Service Bulletin

Bulletin No.: 10-06-01-008F

Subject: Engine Oil Consumption on Aluminum Block/Iron Block Engines with Active Fuel Management (AFM) (Install AFM Oil Deflector and Clean Carbon from Cylinder and/or Install Updated Valve Cover)

This bulletin is being revised to update the Condition and modify the oil consumption test procedure. Please discard Corporate Bulletin Number 10-06-01-008E (Section 06 – Engine/ Propulsion System).

2740641

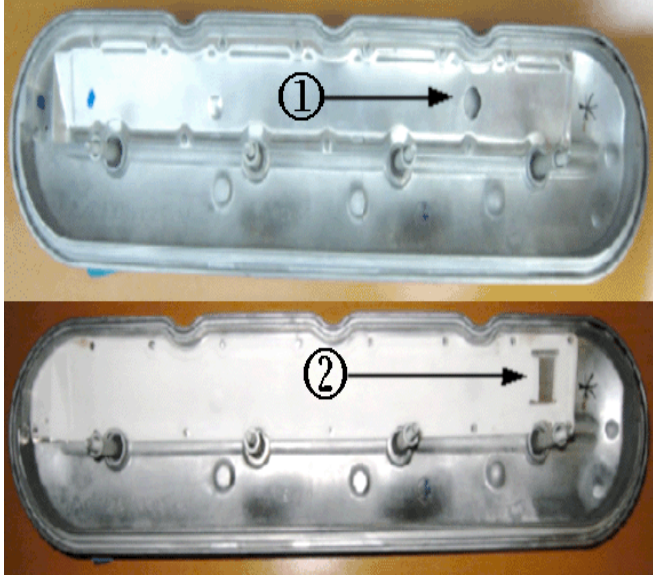
- 1) Old Design
- 2) New Design

PCV pullover or an overactive lifter can cause oil to be pulled through the PCV system even at low vehicle mileage. A correctly functioning PCV system will only leave a film of oil in the intake manifold. Inspect the intake manifold to see if there is any oil puddling in the bottom. If there is you will need to replace the left valve cover. Two new left rocker arm covers have been released for trucks and vans. Technicians should replace the left rocker arm cover with GM P/N 12570427 for 2007-2008 or GM P/N 12642655 for 2009-2011. Refer to the Parts Information below for the Camaro. This rocker arm cover has a relocated PCV drain hole that prevents oil from entering the intake manifold. Refer to Valve Rocker Arm Cover Replacement - Left Side in SI.

Note: These rocker covers are for specific years. The PCV orifice is different for each. The correct cover must be used or an SES light may set.

2474205

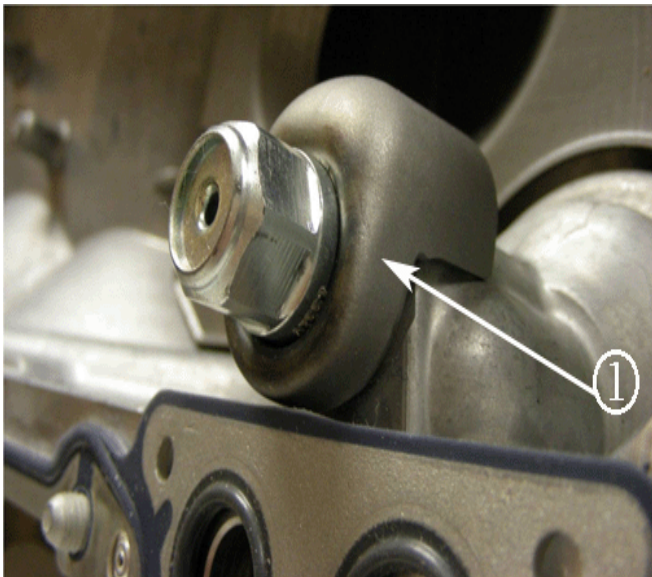
4. Remove the AFM valve (1).
